L-2019-134  
10 CFR 50.54(a)(3)

NextEra Energy Quality Assurance Topical Report (FPL-1) Revision 22 Annual Submittal

Revision 22 is the current version of FPL-1 in use and became effective on June 5, 2019. A summary of the changes for Revisions 22 of FPL-1 is provided in Enclosure 1 of this letter. Enclosure 2 of this letter provides a copy of Revision 22 of FPL-1 for information purposes only.

Enclosures:    1. NextEra Energy QATR (FPL-1) Change Summary (June 2019)  
                  2. NextEra Energy QATR (FPL-1) Current Version (Revision 22)

Appendix E: Organization Charts  
Chart 1 of 2: Corporate

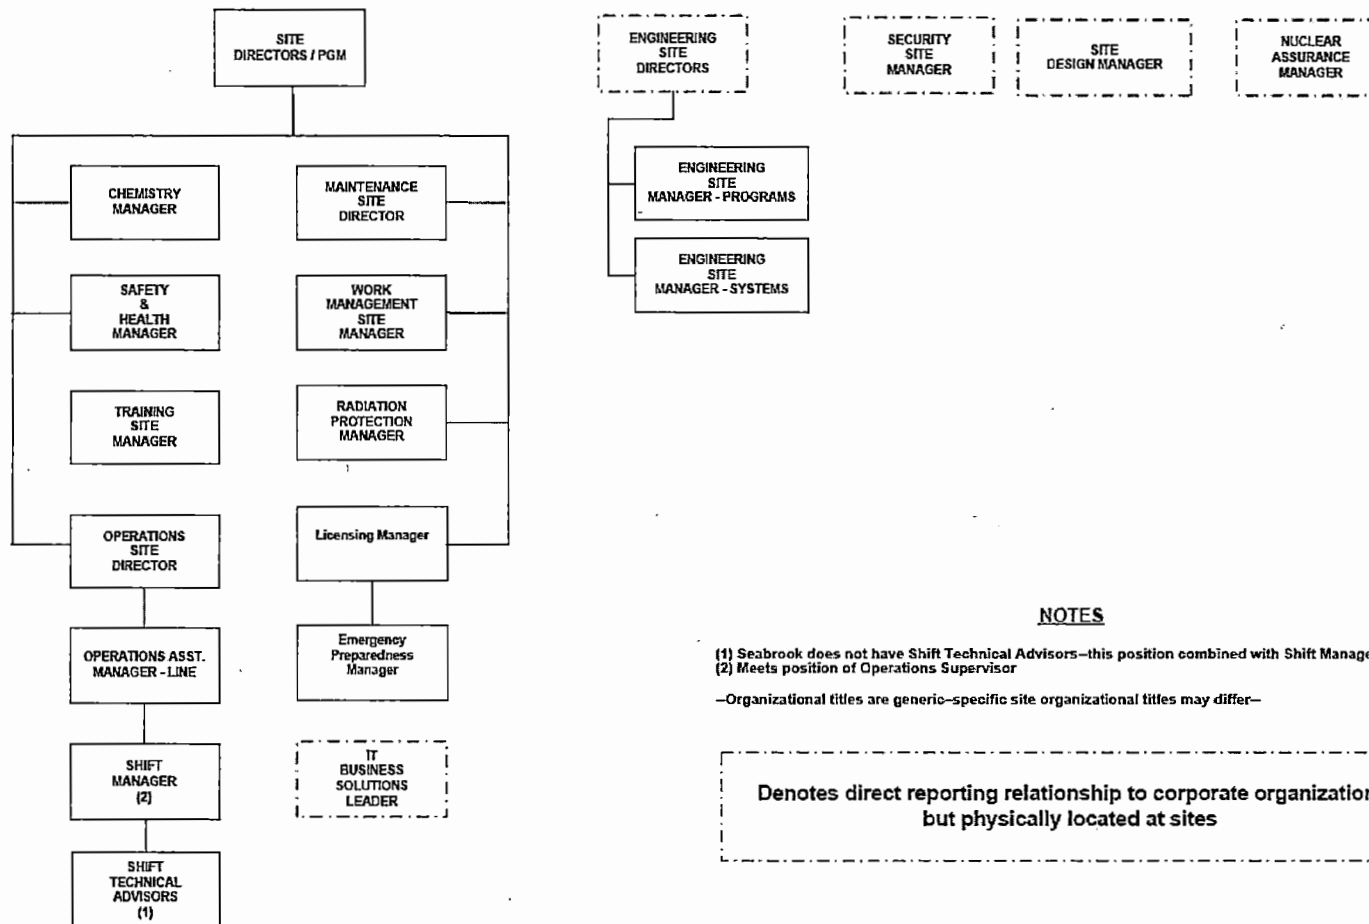
Revision 22	
Change/Reason for Change	Basis for Meeting 10CFR50
<p><b>QR052:</b> Section A.2 Organization &amp; Appendix E: Site Organization Chart.</p> <ul style="list-style-type: none"> <li>- Change the Department Name from Information Management to Information Technology.</li> </ul>	<p>This change was evaluated in accordance with 10 CFR 50.54(a), <i>Conditions of License</i> requirements.</p> <p>The change is an Organizational revision and persons and organizations performing quality functions continue to have the requisite authority and organizational freedom, including sufficient independence from cost and schedule when opposed to safety considerations and therefore this is not considered a reduction in commitment.</p>
<p><b>QR053:</b> This revision has been prepared to update the QATR to reflect the current organizational structure and update the table for the independent assessments to reflect that the Maintenance and Work Management audits are now performed as one audit versus two (change made to NA-AA-202-1000, Audit Topic Selection and Scheduling, Rev 11)</p>	<p>Organizational changes:</p> <p>These changes were evaluated in accordance with 10 CFR 50.54(a) requirements. The changes are an Organizational revision and persons and organizations performing quality functions continue to have the requisite authority and organizational freedom, including sufficient independence from cost and schedule when opposed to safety considerations and therefore this is not considered a reduction in commitment.</p> <p>Change in audits:</p> <p>The table was changed to reflect that the Maintenance and Work Management audits are now performed as one audit versus two. As both areas are still audited there is no reduction in commitment.</p>
